The Droves Solar Farm

Statement of Common Ground (SoCG) with Breckland Council (Tracked)

Prepared by: DWD
Date: October 2026
PINS reference: EN0110013
Document reference: APP/5.11.3 (Revision 3)
Infrastructure Planning (Examination Procedure) Rules 2010

Project:	Title:	Revisions:	Drawn by:	Checked by:	Status	Date:	Drawing no:	Rev:
The Droves, Breckland	Energy Infrastructure Projects (Swaffham and Dereham)		JBG	PJR	Information	13/08/2026	25-23-IN-02

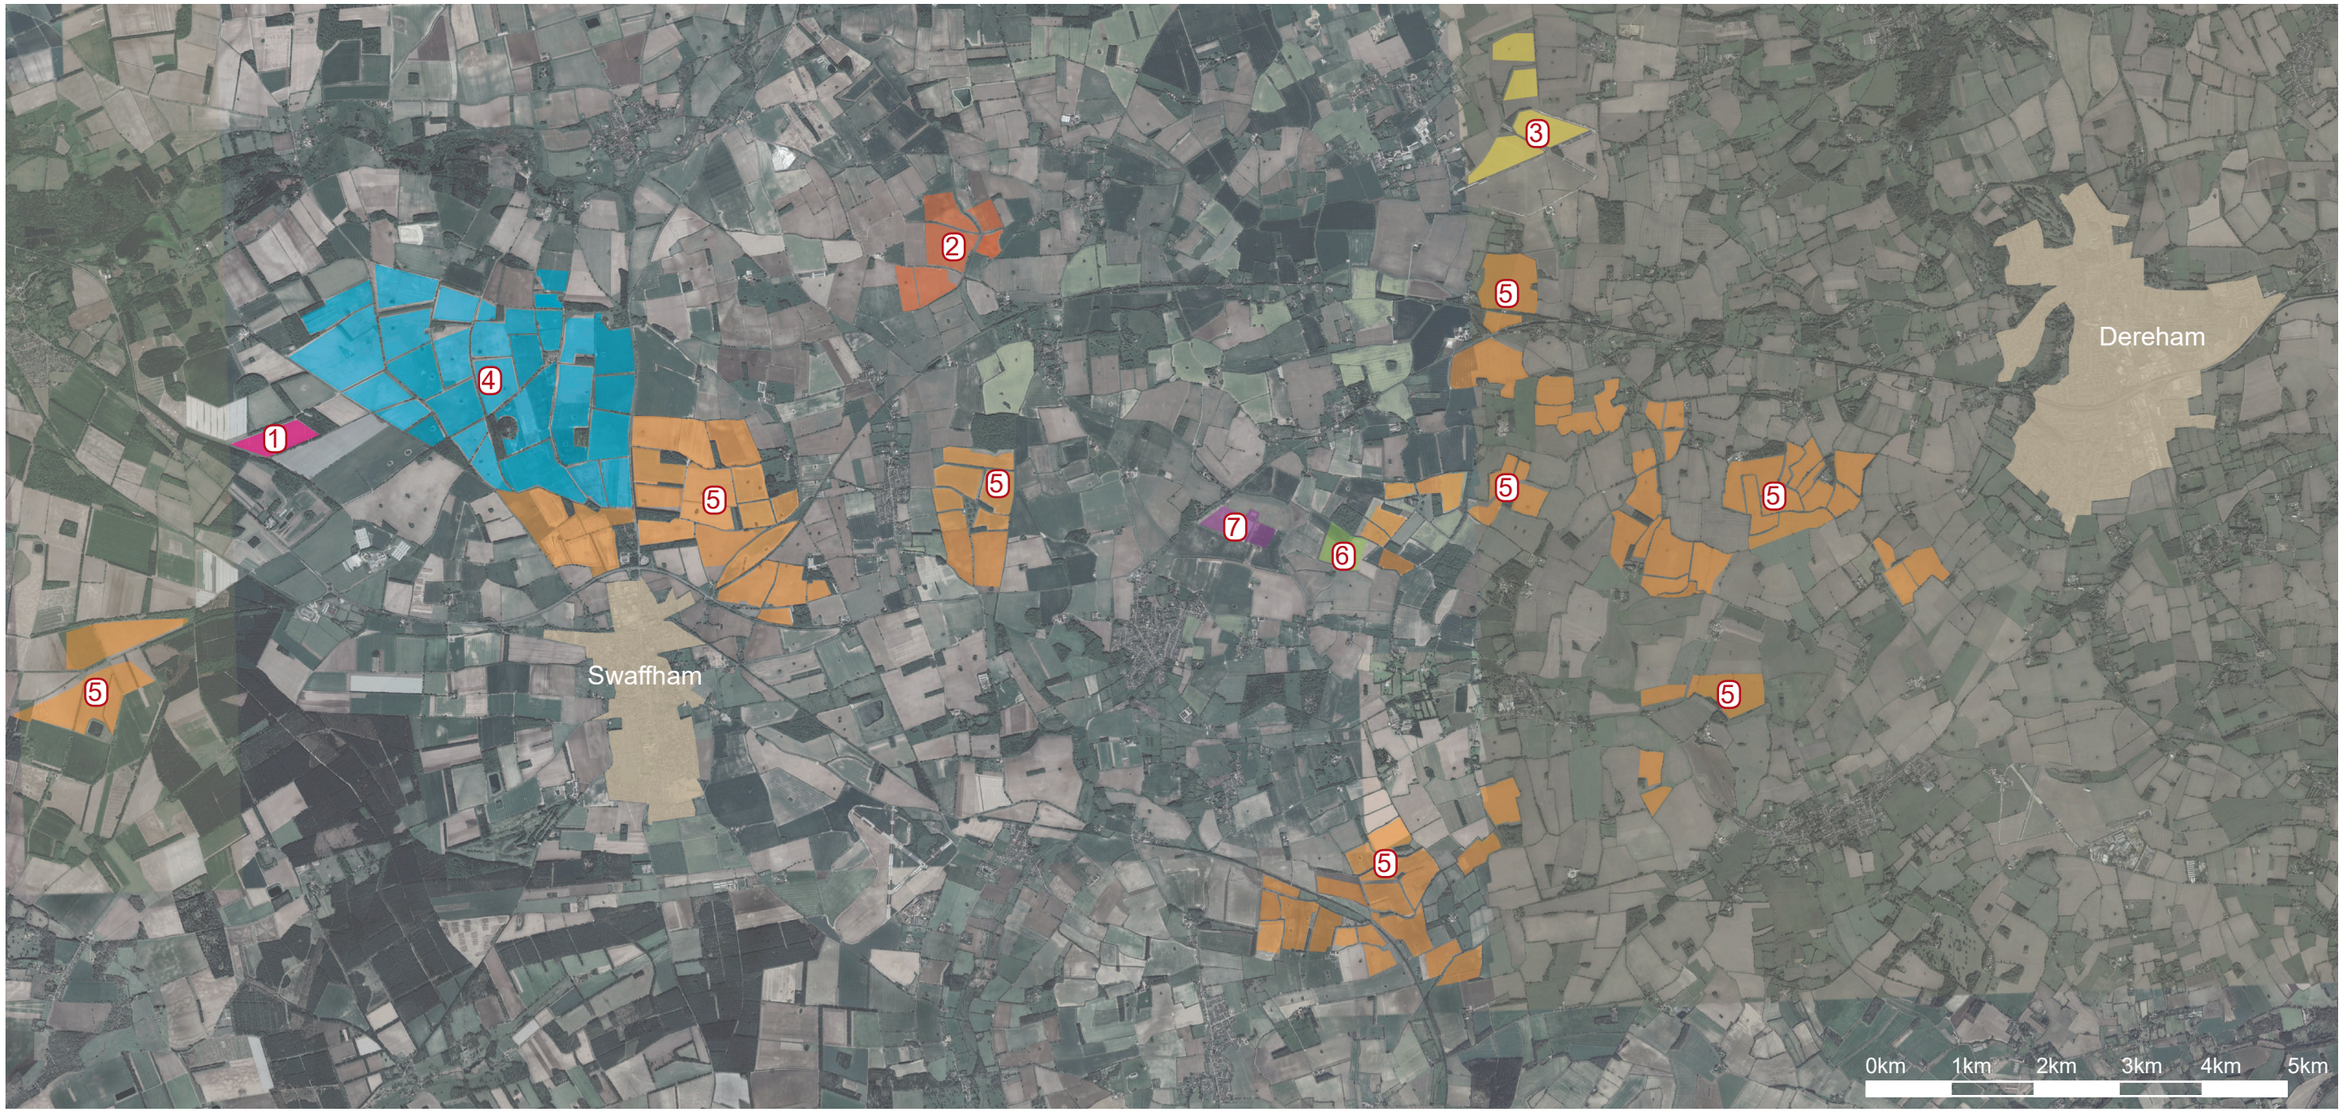
Reference	Topic	Consultee's Position	Applicant's Position	Status
BC 1-1	Cumulative Effects	**Scope of Cumulative Assessment** The Council maintains its concerns about the consideration/acknowledgement of cumulative effects associated with energy infrastructure projects coming forward in Breckland and the wider Norfolk area. Whilst it is noted that the applicant's methodology for assessing cumulative effects may align with the PINS guidance, this does not change the fact that the proposal would result in notable changes to character across a wider area. Indeed, it is noted that the ExA requested an interrelationship report which was to include Norwich to Tilbury and East Pye Solar. **Landscape Assessment** The applicant has used the Breckland Landscape Character Assessment (May 2007) for their baseline assessment work. This is the Council's adopted evidence base. However, it is nearly 20 years old and, while it does make and reference of the capacity of the landscape to accommodate wind turbines, it does not make reference to the capacity of the	The Applicant acknowledges that the Council no longer wish to engage on this matter and that this is their final position. **Scope of Cumulative Assessment** **ES Chapter 6: Landscape and Visual [AS-016]** outlines the approach and the likely cumulative effects arising from the proposed Scheme in-combination with other developments. The list of cumulative schemes has been narrowed down to focus on those developments which are likely to give rise to significant cumulative landscape and visual effects; informed by the ZTV for the Scheme as well as desk based assessments and field observations. The Applicant considers it unnecessary to extend the study area to accommodate other energy infrastructure when intervisibility would diminish due to intervening vegetation and topography resulting in not significant cumulative landscape and visual effects. A further response to the consultee comments on cumulative landscape and visual effects as well as the adequacy of the Council's adopted evidence base; Breckland Landscape Character Assessment, May 2007 with supporting site observations is provided in the	Not agreed

BC 1-5	Cumulative Effects	Table 2.2 of the applicant's **ES Appendix 2.4: Cumulative Schemes [REP3-063]**, references the basis on which the additional developments were selected for inclusion within the cumulative assessment. For the LVIA this was based on the Zone of Theoretical Visibility of The Droves scheme in isolation and hence comes up with a 3km radius, with the only scheme falling within that radius being High Grove. The Council believes this is over simplistic and does not adequately consider the potential for cumulative effects across the wider area. GLVIA3 7.1 goes into further detail regarding the assessment of cumulative views 'in combination', 'in succession', 'frequently sequential' and 'occasionally sequential'. The Council requested further work to be undertaken in order to have a fuller understanding of the likely cumulative effects arising from similar projects with the wider area. Whilst the requested overlapping ZTV with Little Dunham has not been provided, it is noted that the applicant has assessed the cumulative effects for views in Receptor Group f (Great Palgrave and Little Palgrave) to be significant adverse.	The Applicant acknowledges that the Council no longer wish to engage on this matter and that this is their final position. The Applicant has committed to keeping the long list and short list under review during the examination and has consulted Breckland Council during the examination period and asked Breckland Council to identify any further cumulative developments that are not already listed on the long list as set out in **ES Appendix 2.4: Cumulative Schemes [REP3-063].** The Applicant submitted an updated long and short list at Deadline 3. In terms of the LVIA the list of cumulative schemes has been narrowed down to focus on those developments which are likely to give rise to significant cumulative landscape and visual effects; informed by the ZTV for the Scheme as well as desk based assessments and field observations. A further response to the consultee comments regarding cumulative landscape and visual effects is provided in the **Technical Information Note – Landscape and Visual [REP3-083]** and this note explains the reasons overlapping ZTVs of the scheme with High Grove DCO have not been considered necessary. The Applicant considers it unnecessary to extend the LVIA study area to accommodate other energy infrastructure when intervisibility	Not agreed
